**Origination Form**  
Proposed Revisions to a Standard Plans Index

<b>Originator:</b>	Turley, Joshua	<b>Index Number:</b>	700-091
<b>Date:</b>	4/23/2025	<b>Sheet Number(s):</b>	Sheet 2
<b>E-mail:</b>	Joshua.Turley@dot.state.fl.us	<b>Index Title:</b>	CATWALK DETAILS

CATWALK DETAILS

INDEX	SHEET
700-091	2 of 3

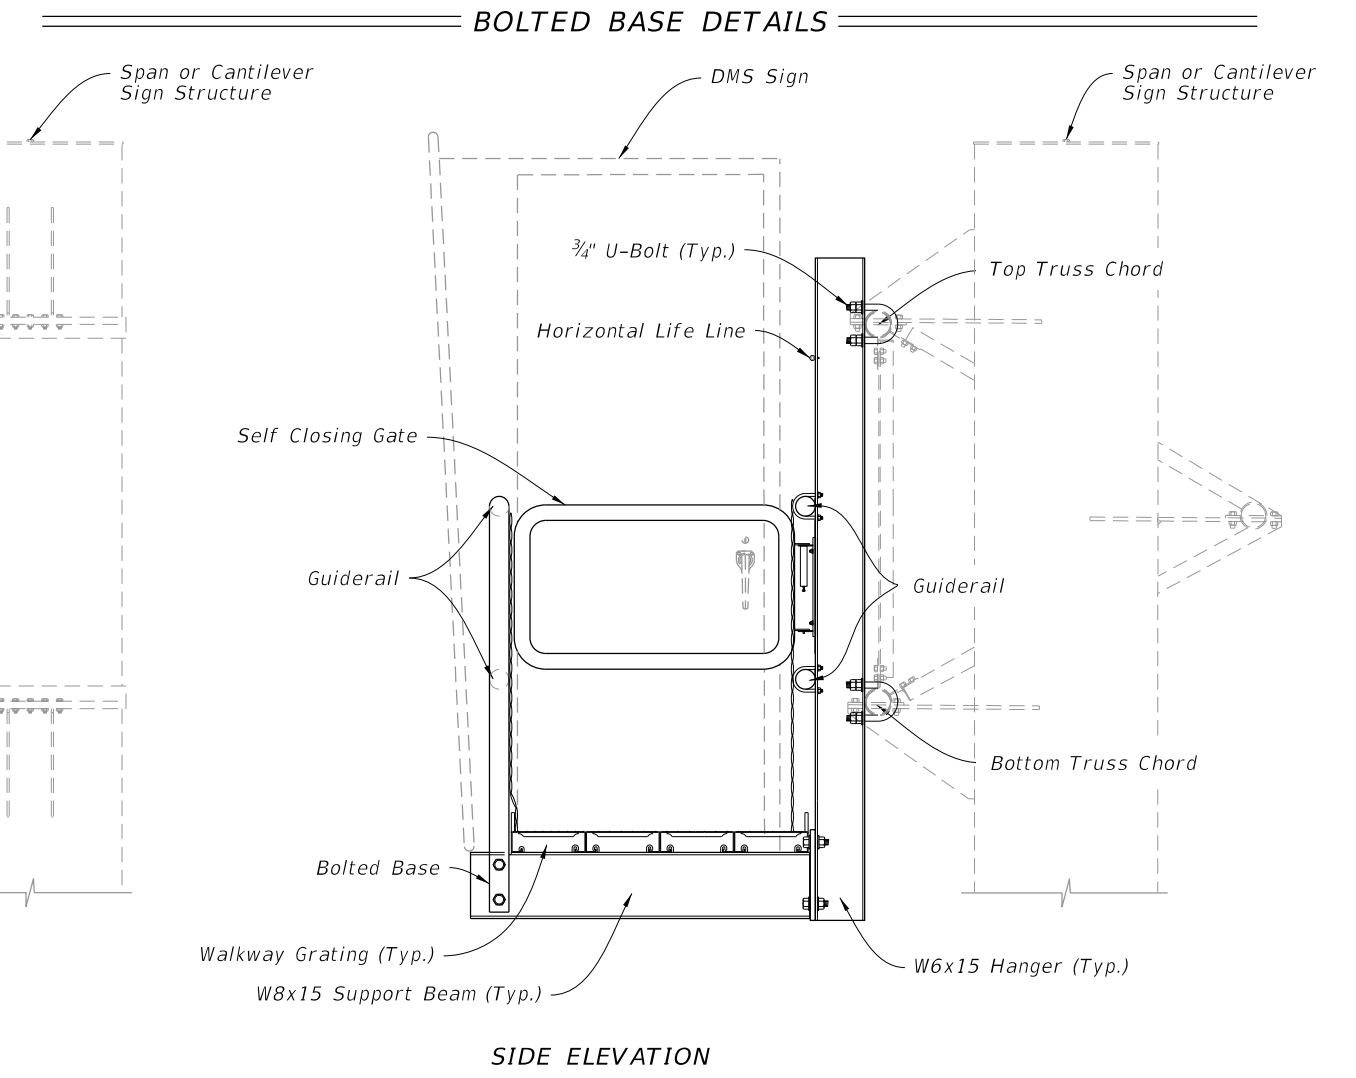
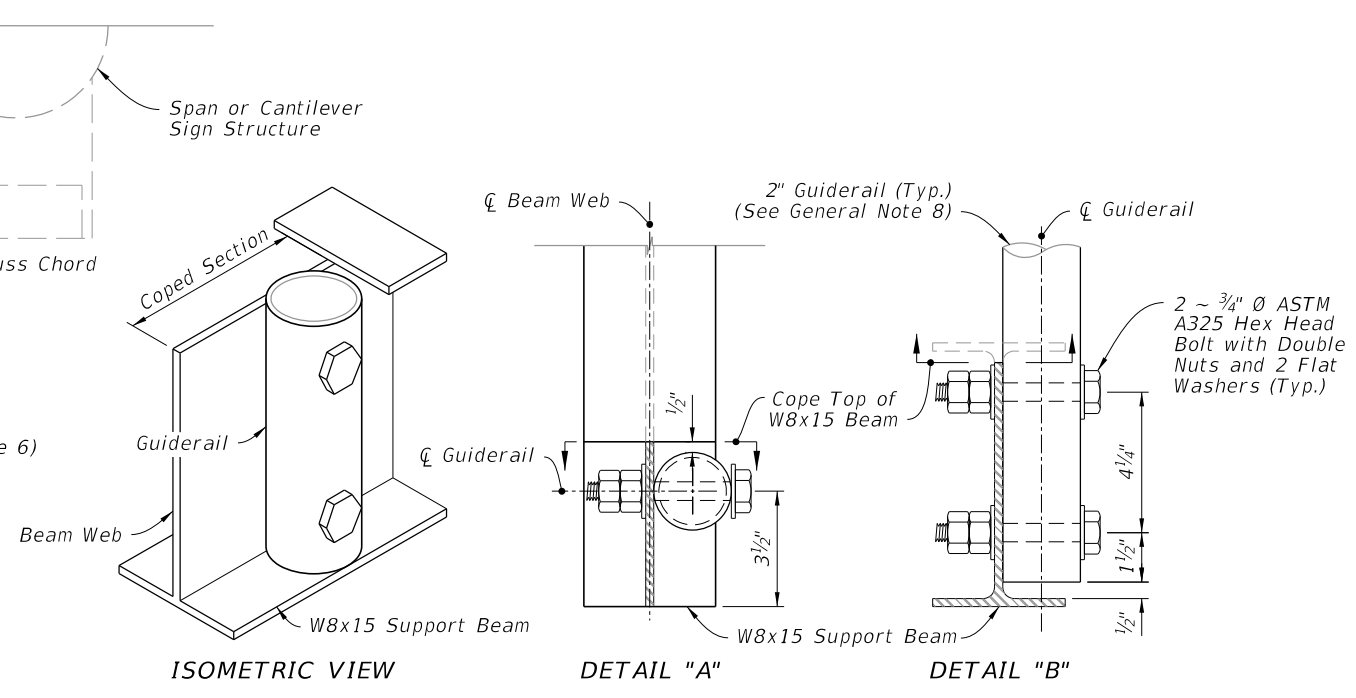
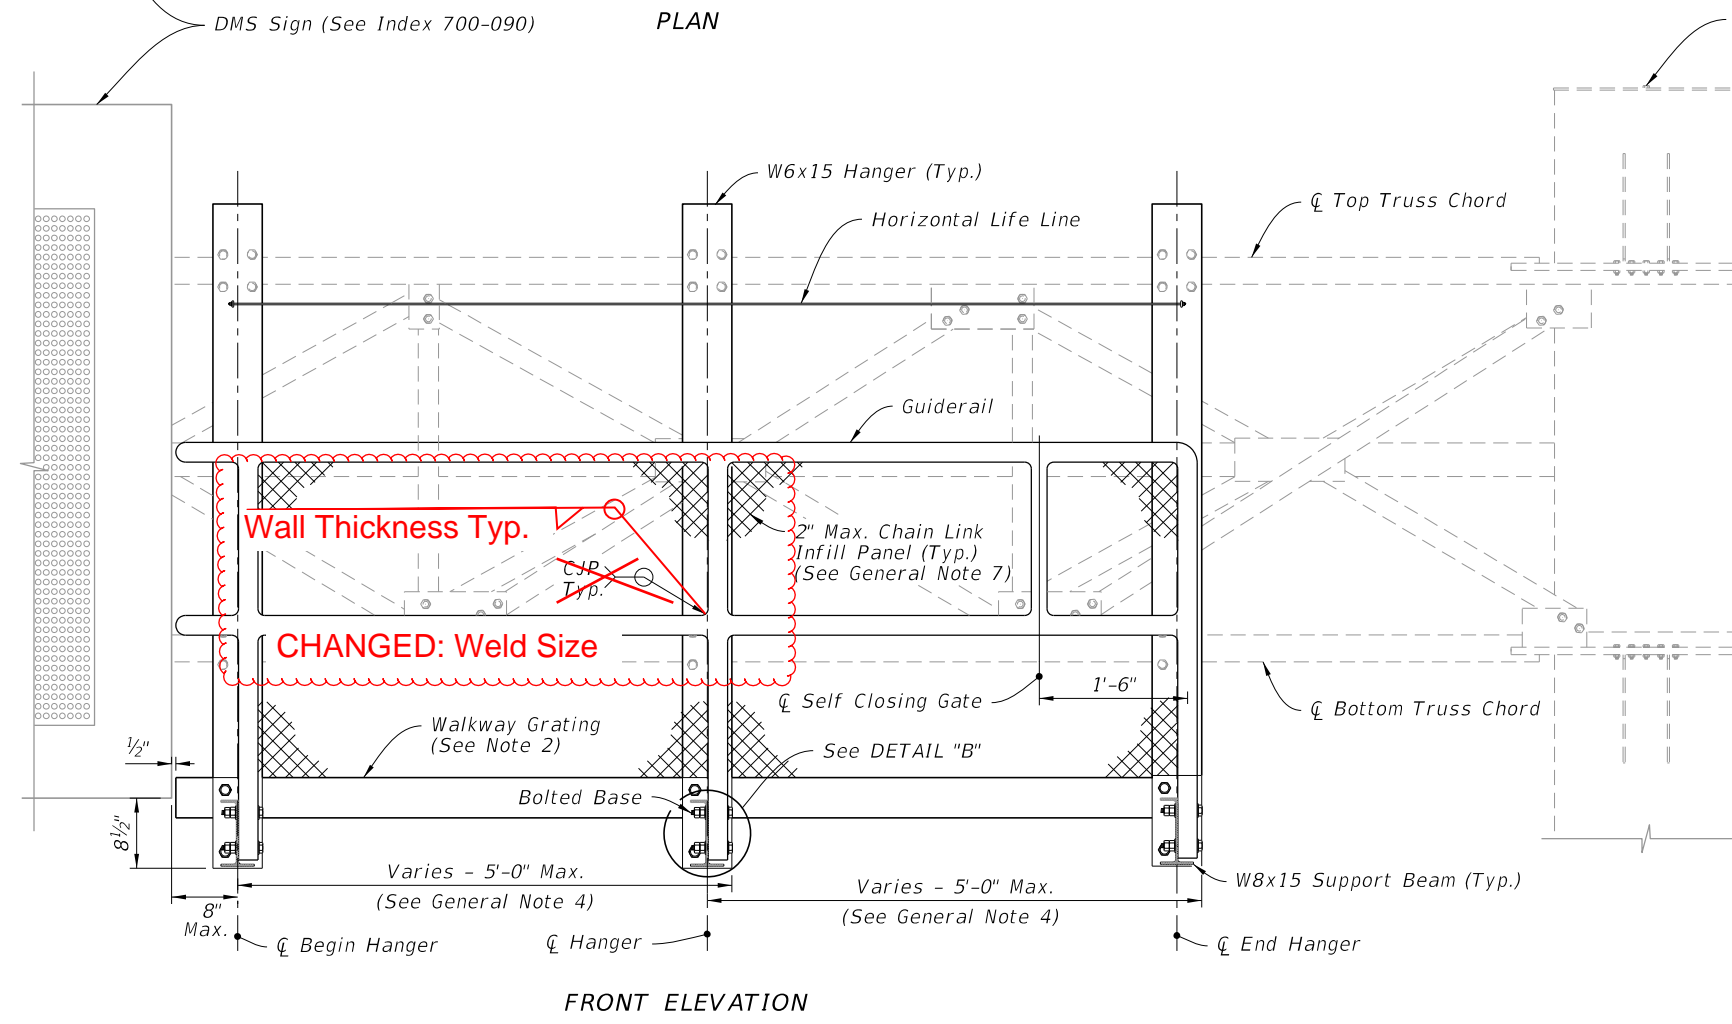
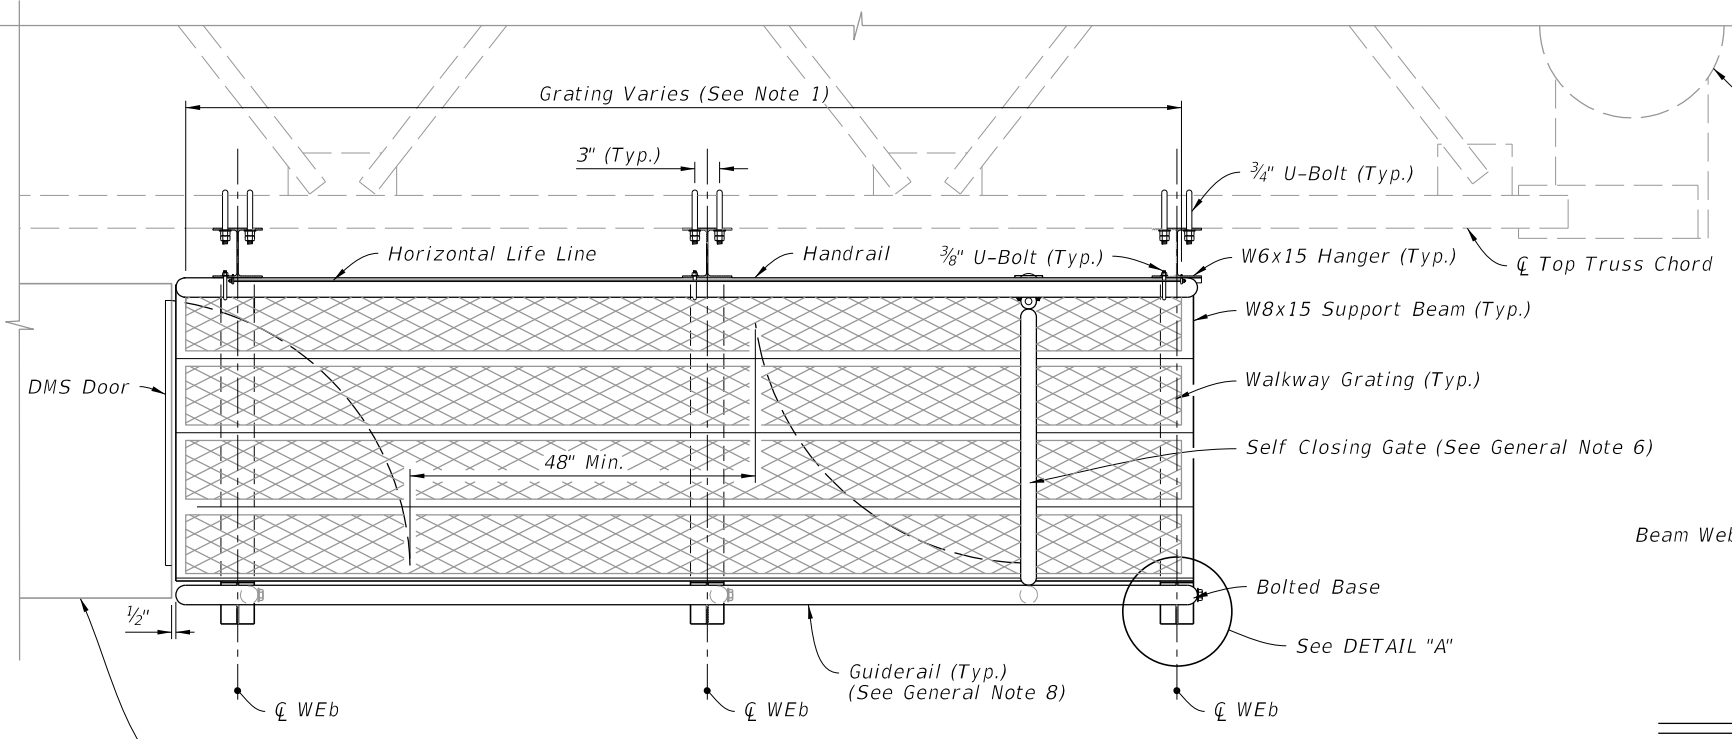
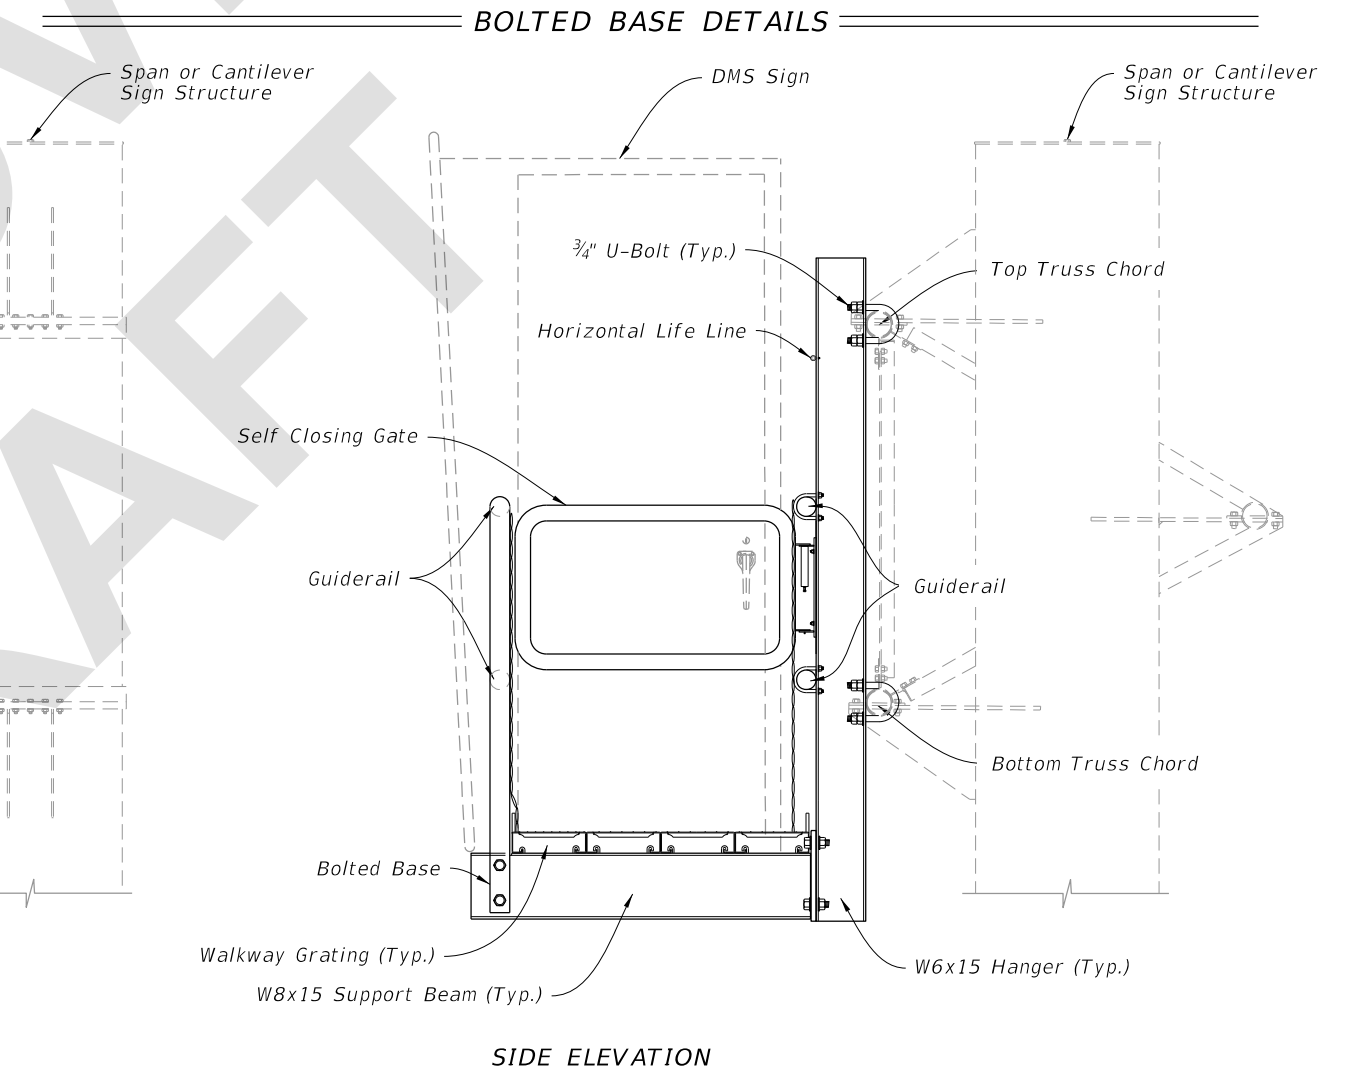
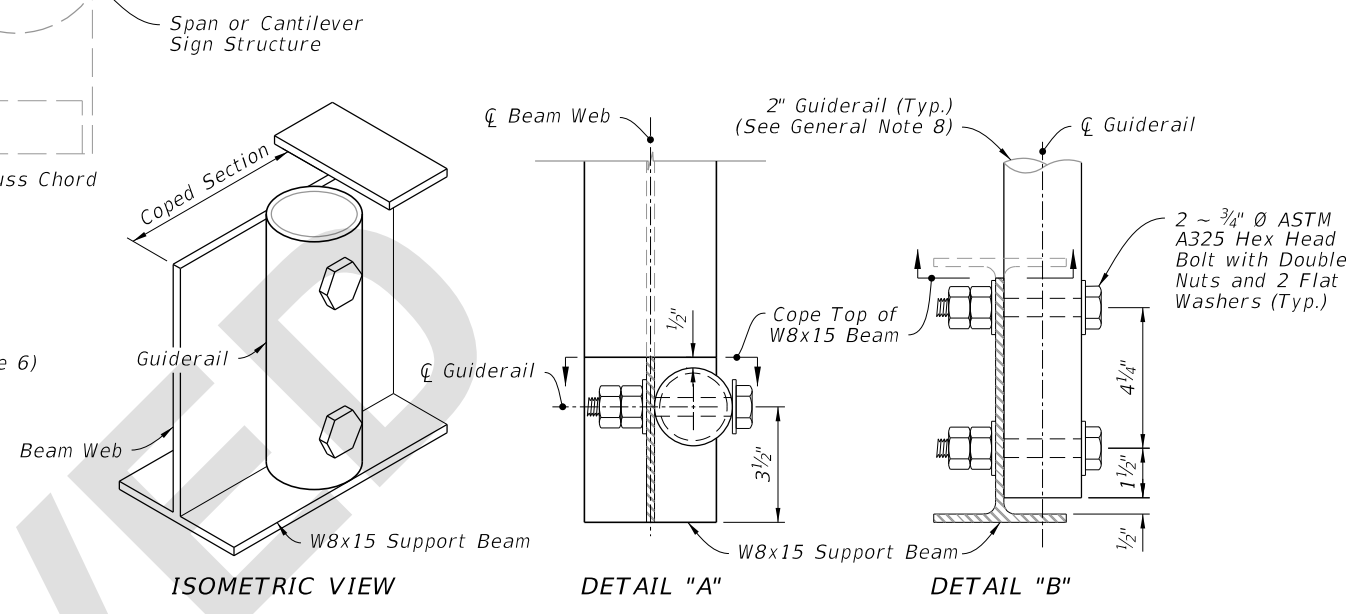
Sheet 2: Changed the weld size for the tube to tube connections of the guardrail.

The original weld size was overly conservative and not cost-effective. After analysis, the Structures Office specified a more appropriate weld for this index.
